RECALL 25V682 / 2025-545 REMEDY INSTRUCTIONS

Concern:
The charge line may not have over-current protection.

USE THIS REPAIR SPECIFICALLY FOR CLIPPER & VIKING

CERTAIN – 2026 – CLIPPER TRAVEL TRAILERS
CERTAIN – 2026 – VIKING TRAVEL TRAILERS

FIGURE 3 - INCORRECT

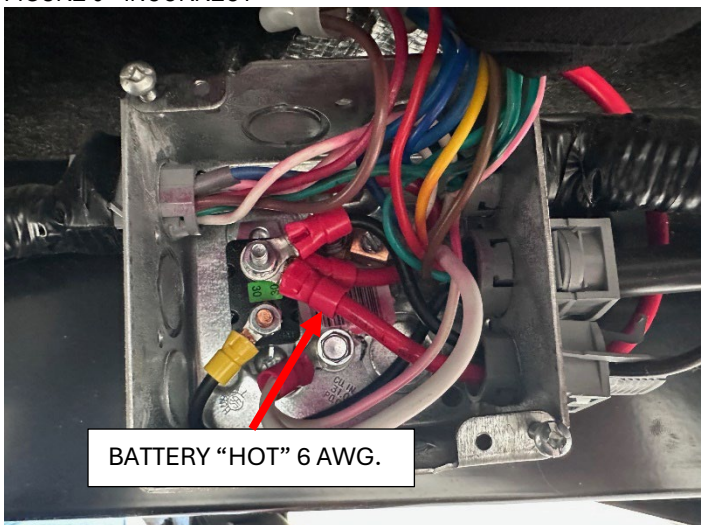
STEP 2: IF THE 6 AWG. WIRES ARE CONNECTED AS SHOWN IN FIGURE 3, MOVE ON TO THE REMEDY;

STEP 1: LOCATE THE 6 AWG. RED WIRES ON THE SAME POST OF THE MINI-BREAKER.

- LOOSEN THE NUT AND REMOVE THE WIRE/EYELET BATTERY LEAD RED 6 AWG. WIRE;

STEP 2: INSTALL THE NUT BACK ONTO THE POST YOU REMOVED IT FROM AND TIGHTEN DOWN, ASSURING IT IS SECURE;

STEP 3: REMOVE THE NUT FROM THE LOWER POST ON THE MINI-BREAKER;

- INSTALL THE 6 AWG. RED "HOT" FROM THE BATTERY WIRE/EYELET ONTO THE POST;
- THE REMEDY SHOULD NOW MATCH FIGURE 2;
